**ADDENDUM # 1**

<b>Project</b>	TA Blakelock High School Renovations	<b>Project No.</b>	2215-C
<b>Location</b>	1160 Rebecca Street, Oakville, ON	<b>Date of Issue</b>	2025 04 24
<b>Owner</b>	Halton District School Board	<b>File</b>	2215/7.1.3

This Addendum forms part of the Contract Documents and amends the original Drawings and Specifications, dated 2025 04 17, and all preceding Addenda, as noted below.

3 PARTIAL LEVEL 0 ELEVATOR 01 - NEW PLUMBING PLAN  
M201 1/50

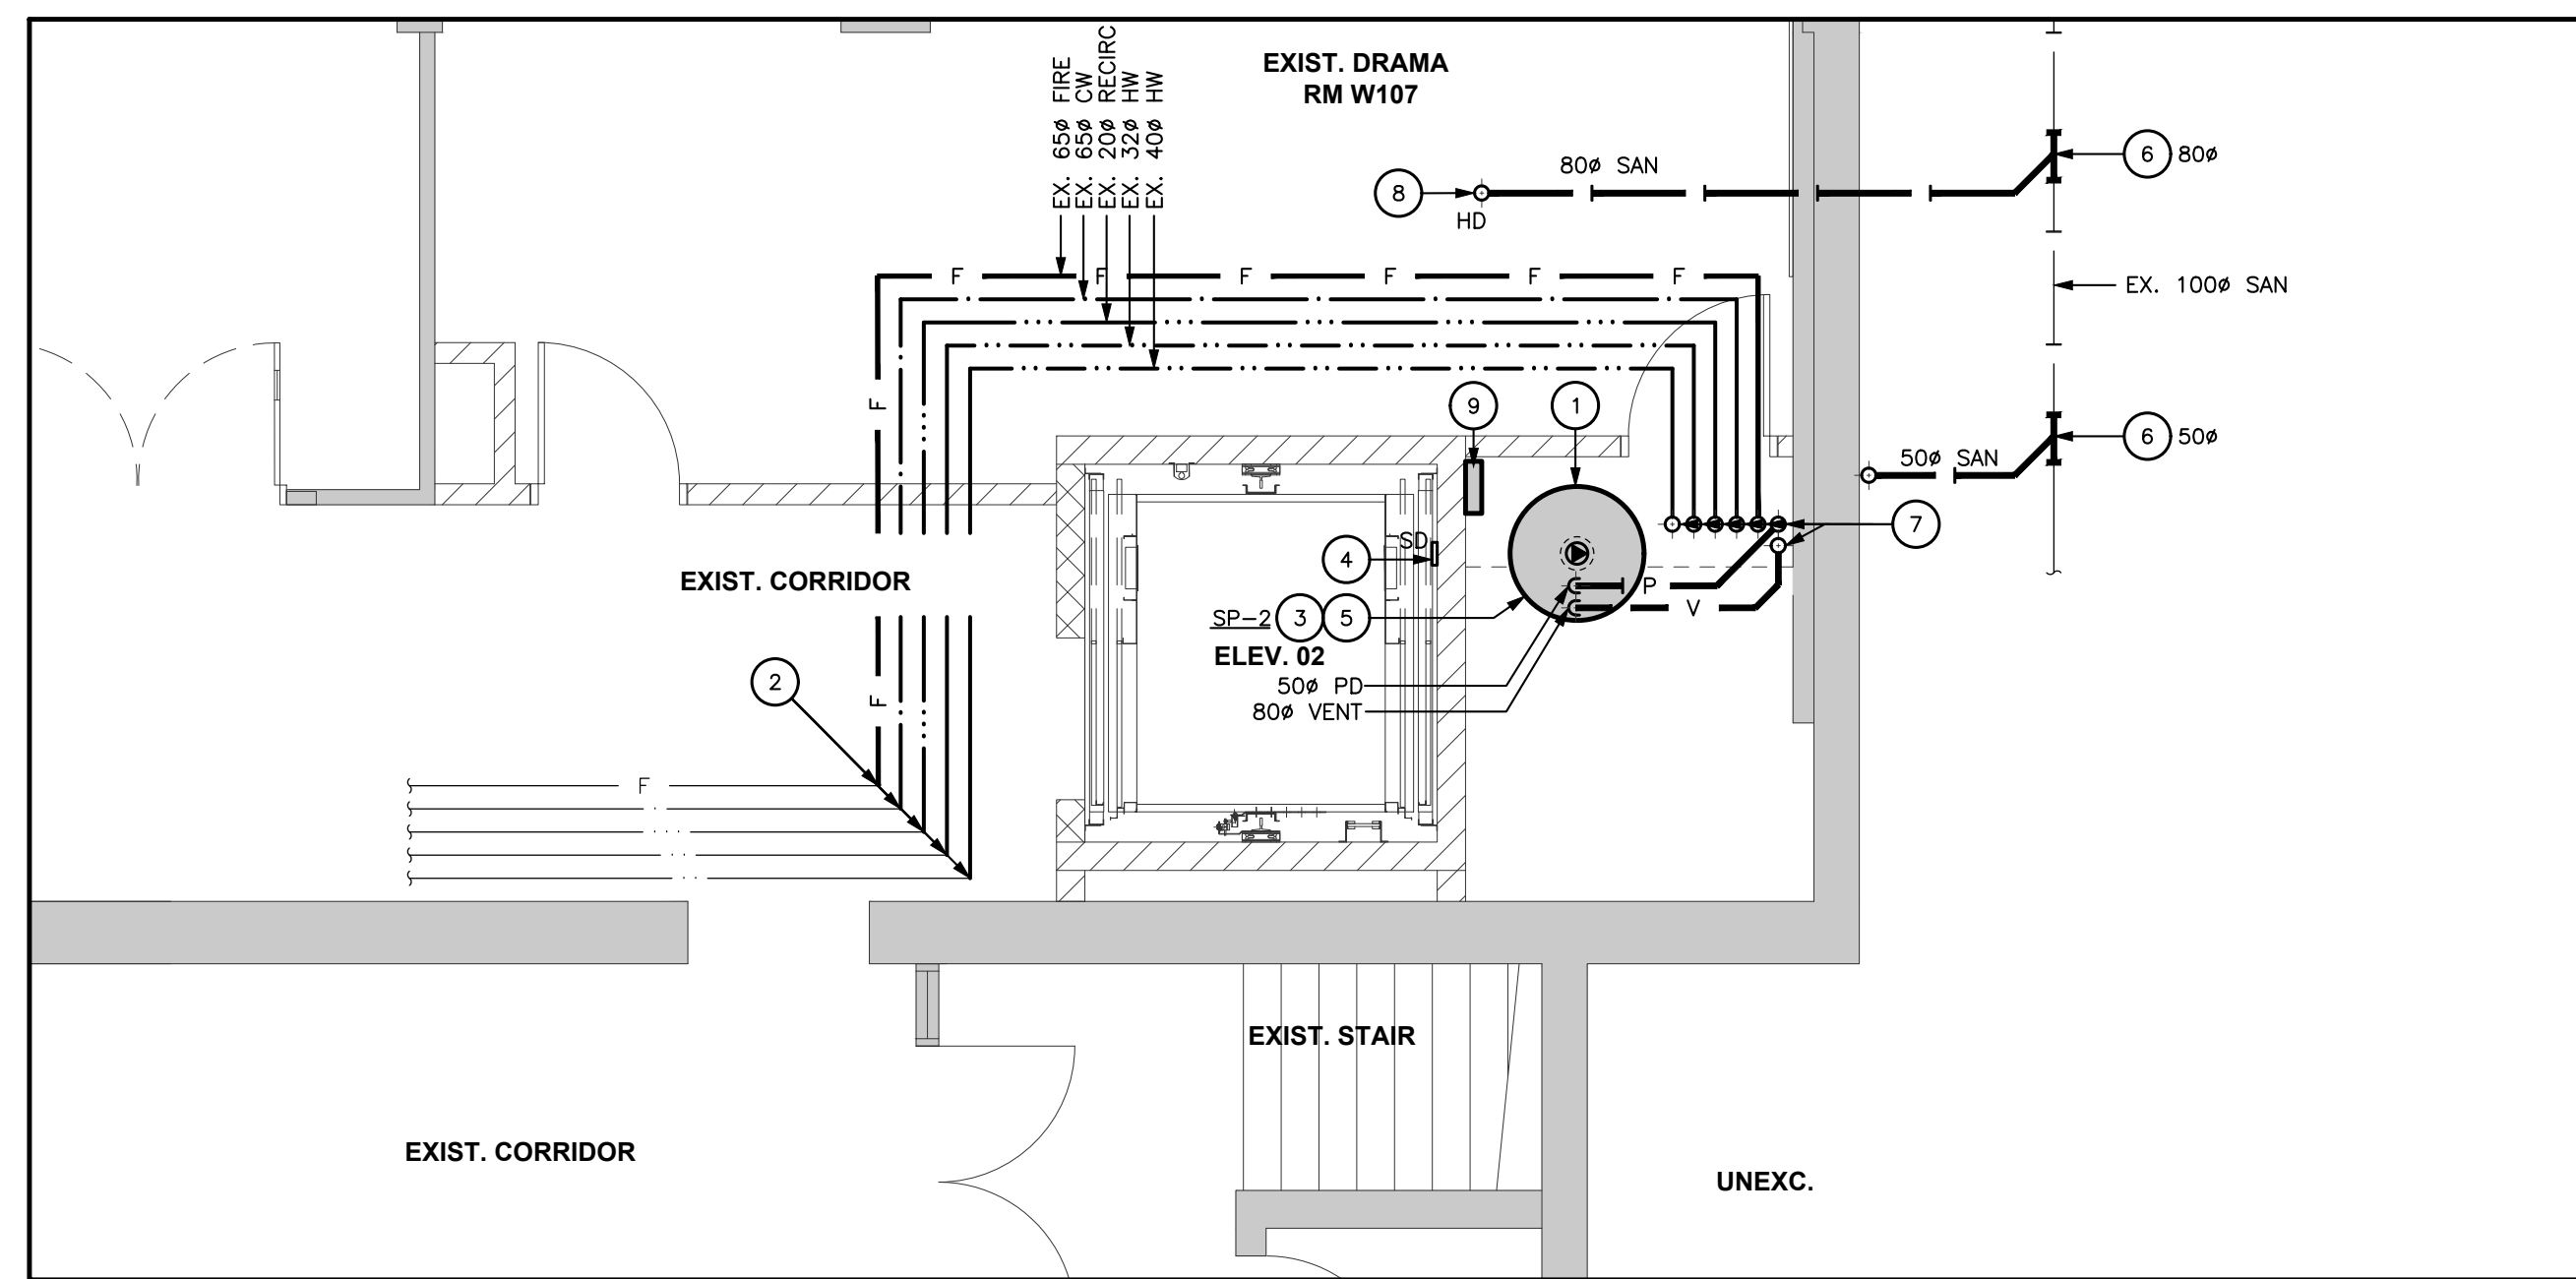
- .2 **Refer to Partial Level 0 Elevator 01 – New Plumbing Plan:**
    - .1 **REVISE** Piping layout as indicated on included drawings.
    - .2 **REVISE** Drawing note 6 to include "...WITHIN NW FURRED OUT WALL."

5 PARTIAL LEVEL 1 ELEVATOR 01 - NEW PLUMBING PLAN  
M201 1/50

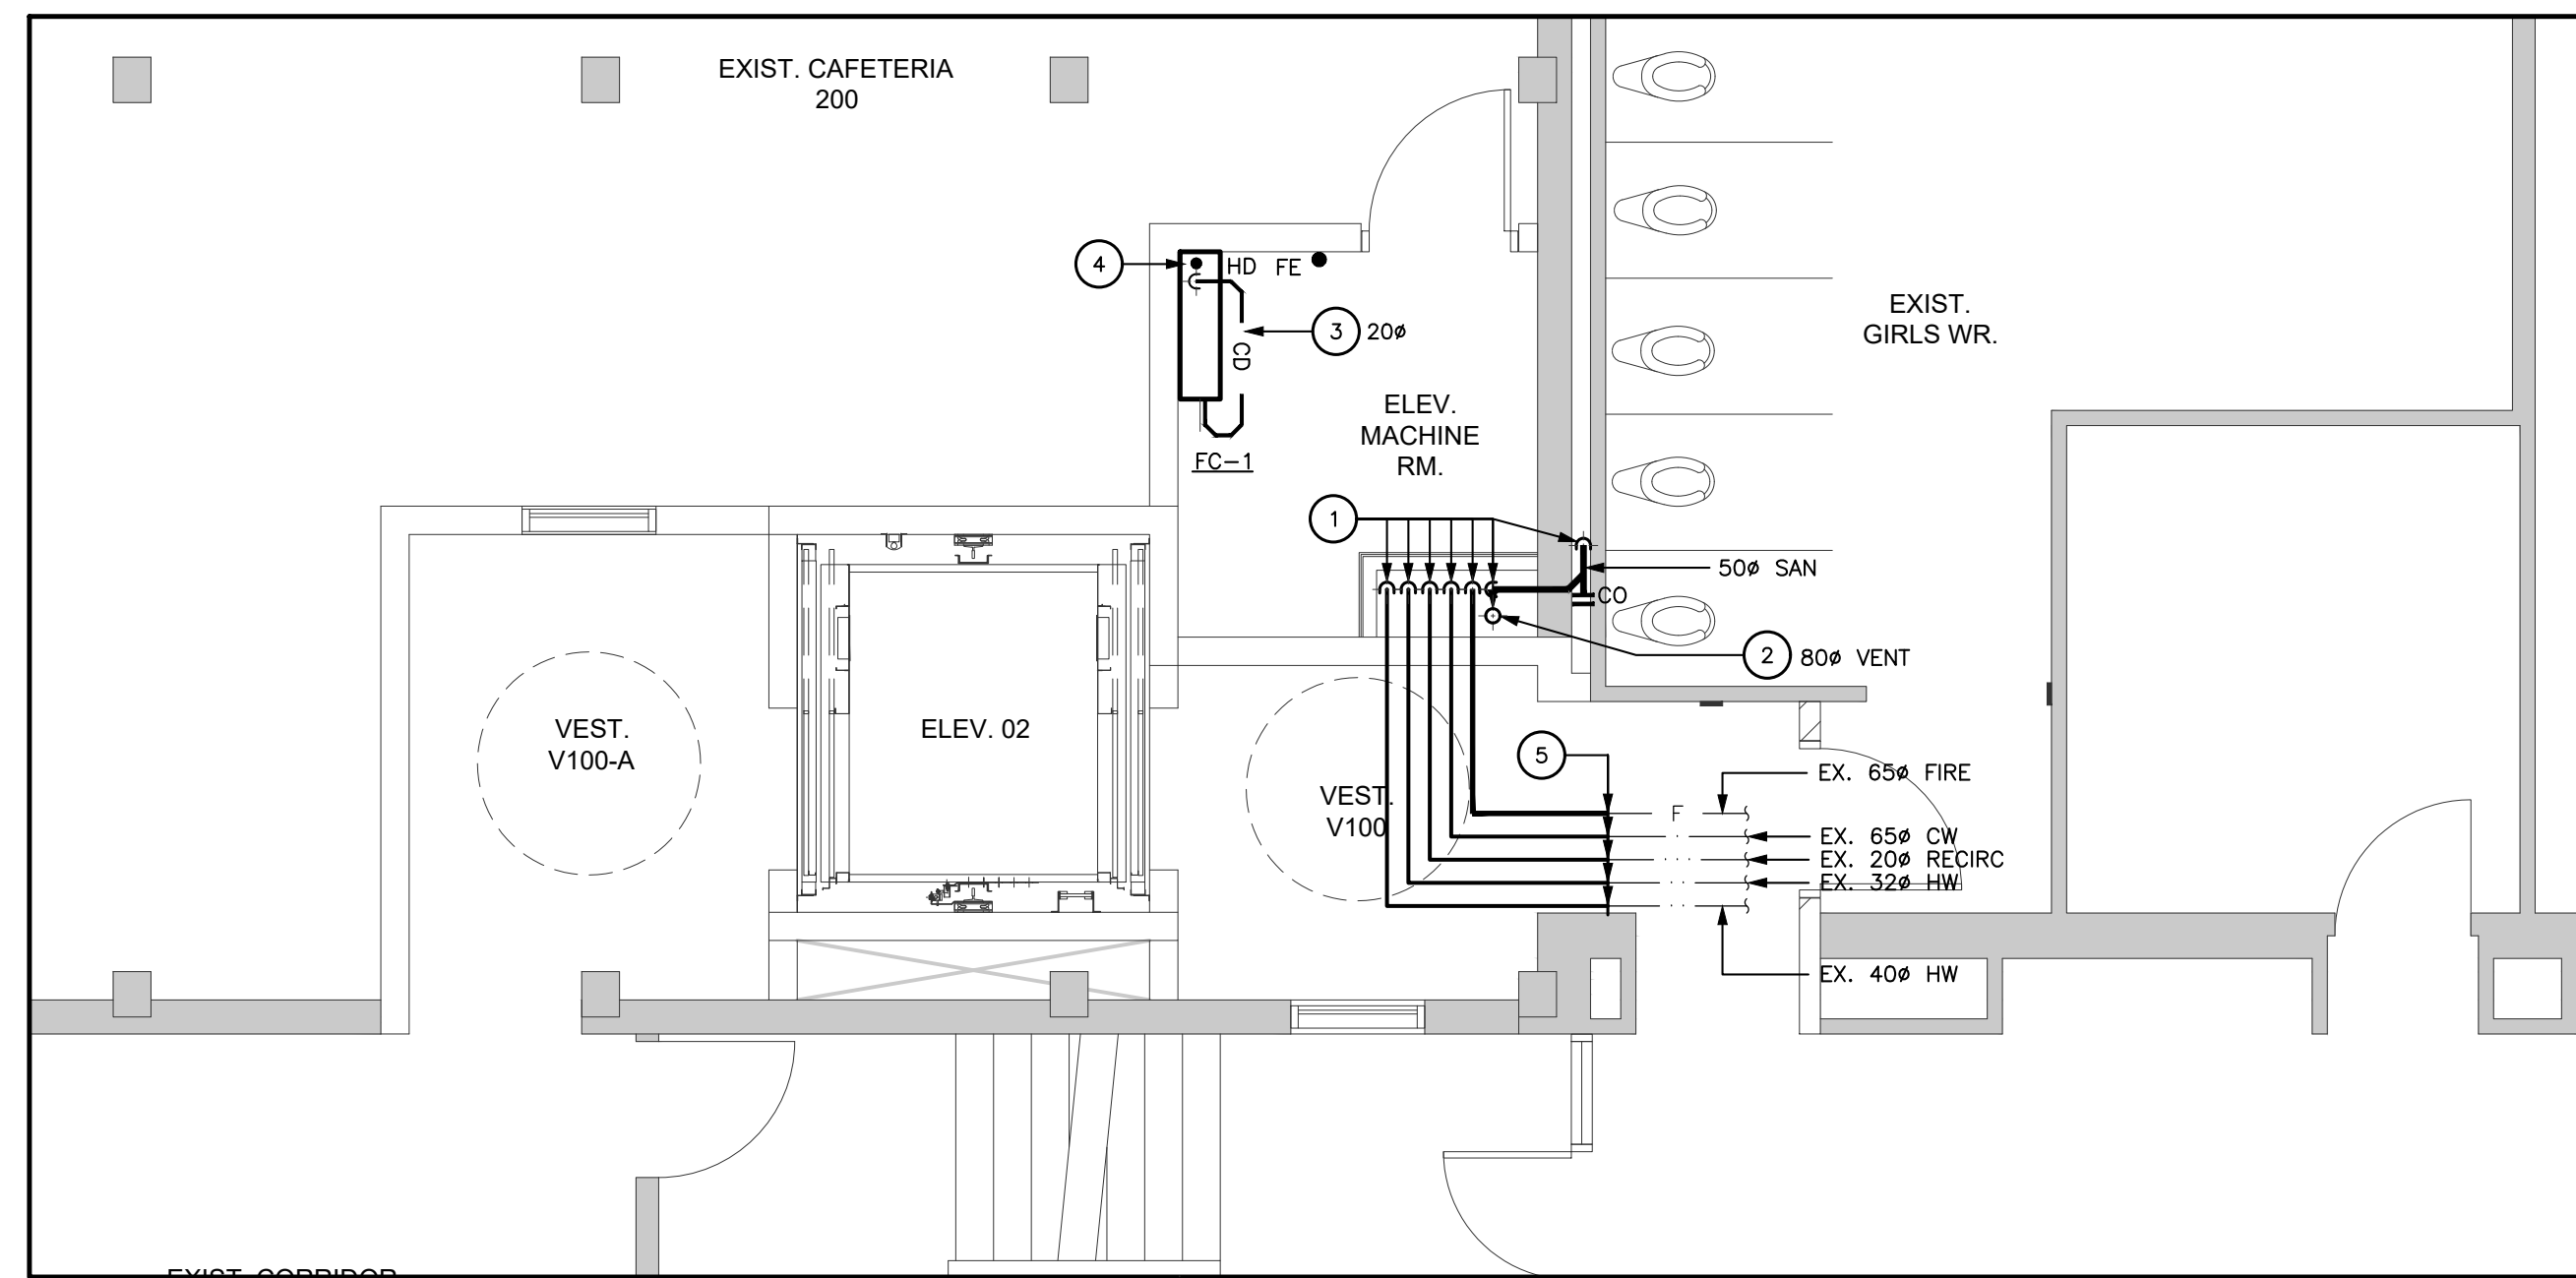
- .3 **Refer to Partial Level 1 Elevator 01 – New Plumbing Plan:**
    - .1 **REVISE** Piping layout as indicated on included drawings.
    - .2 **REVISE** Drawing note 2 to include "...WITHIN NW FURRED OUT WALL..."

2 PARTIAL LEVEL 0 ELEVATOR 01 - NEW HVAC PLAN  
M300 1:50

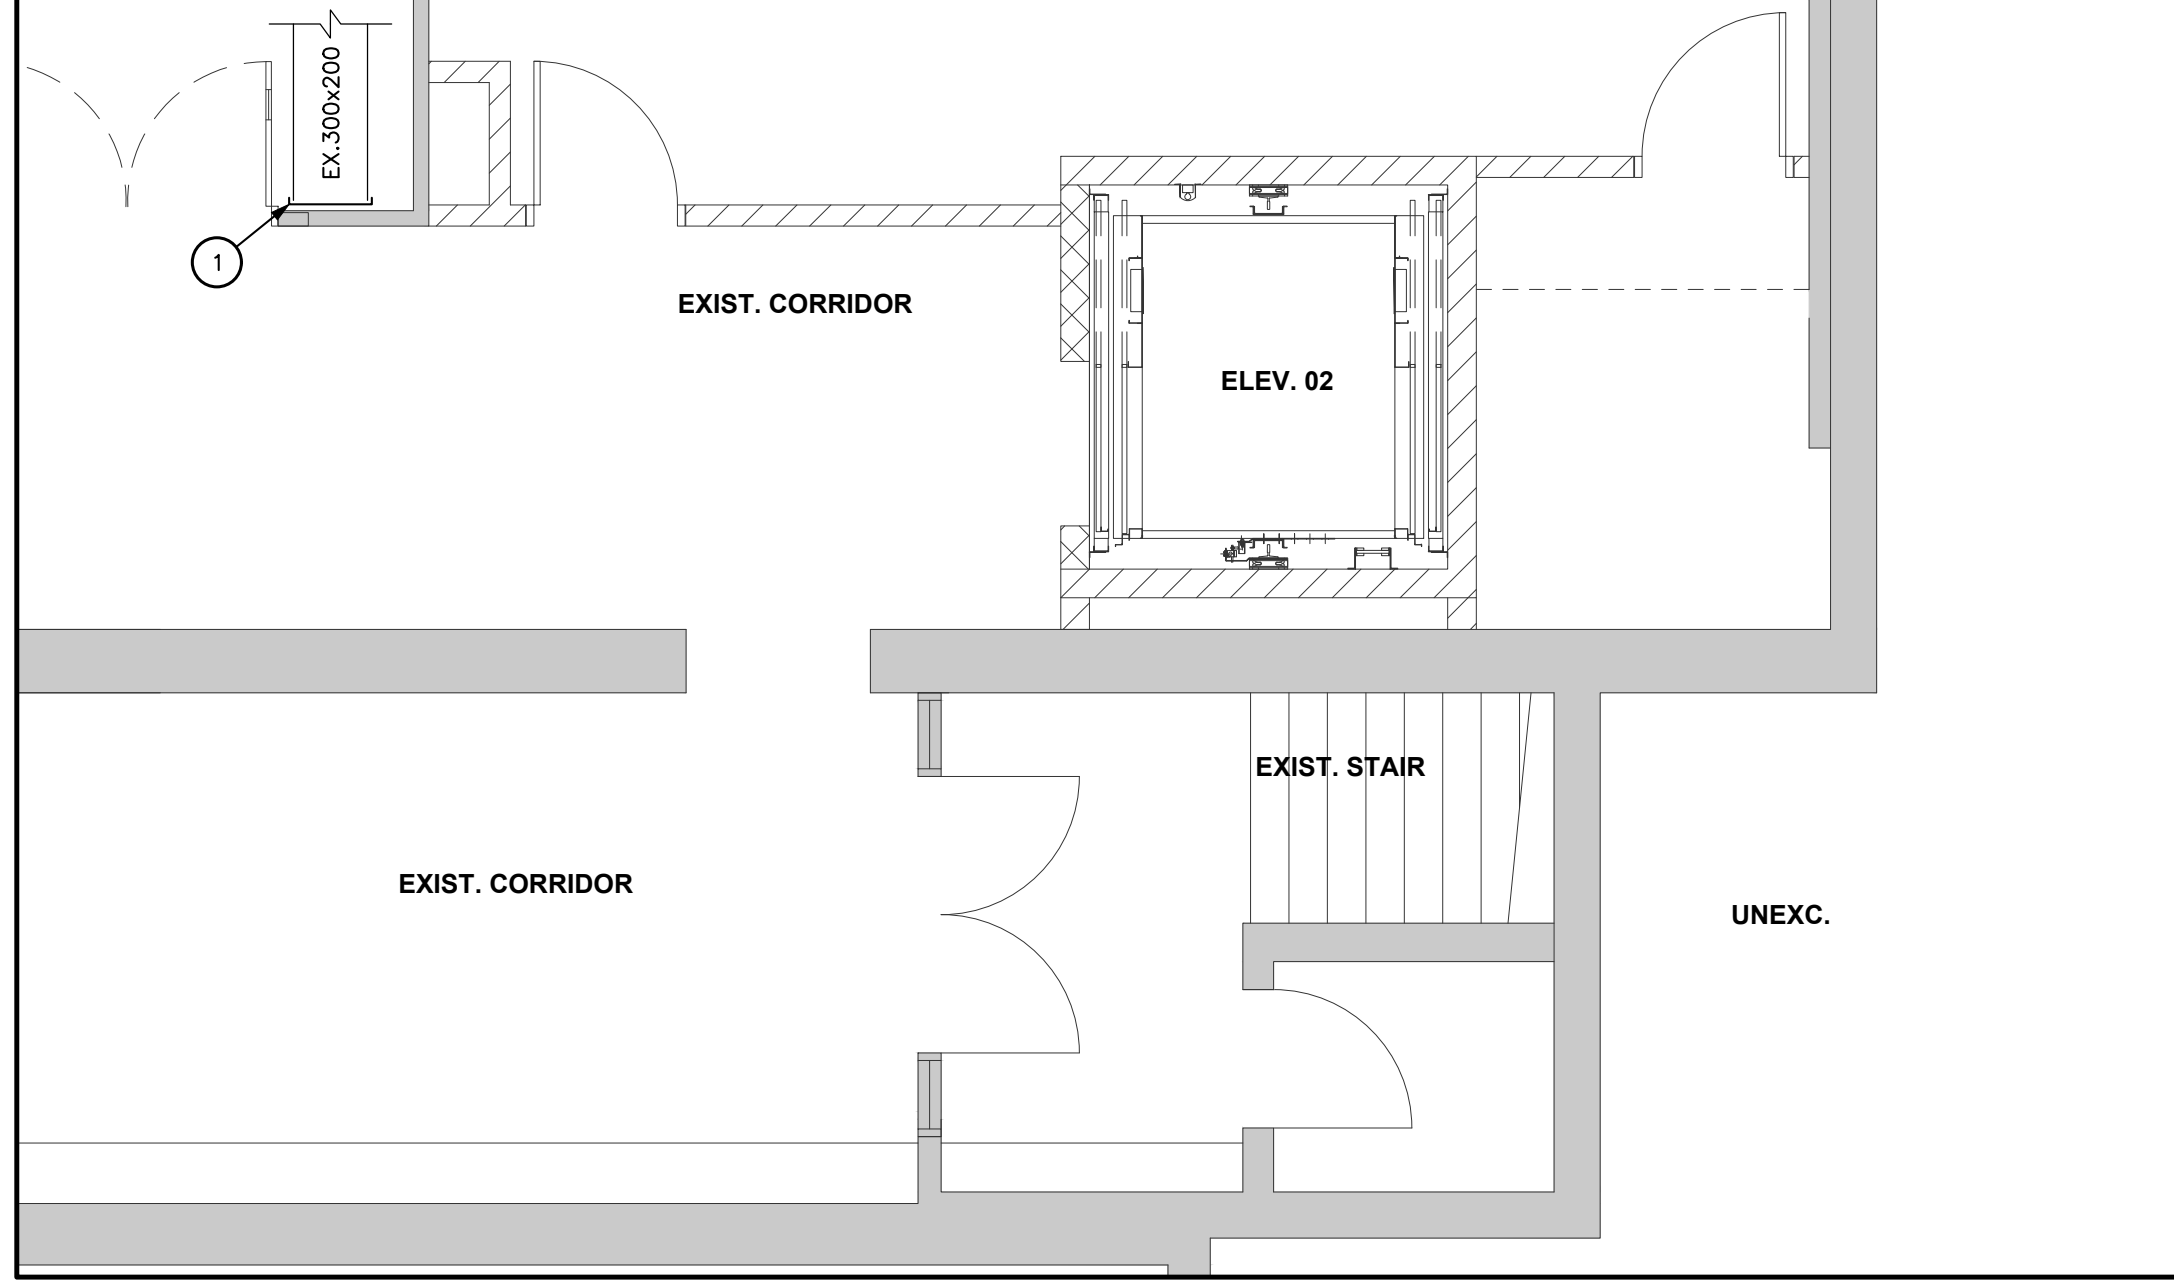
- .2 **Refer to Partial Level 0 Elevator 01 – New HVAC Plan:**
    - .1 **ADD** Fan coil ‘FC-2’ in elevator machine room complete with all piping specialties, controls and condensate drainage.

- .2 **ADD** Refrigerant piping to serve new fan coil.
  - .3 **Refer to Partial Level 1 Elevator 01 – New HVAC Plan:**
    - .1 **ADD** Refrigerant piping dropping from roof level down to floor below within furred
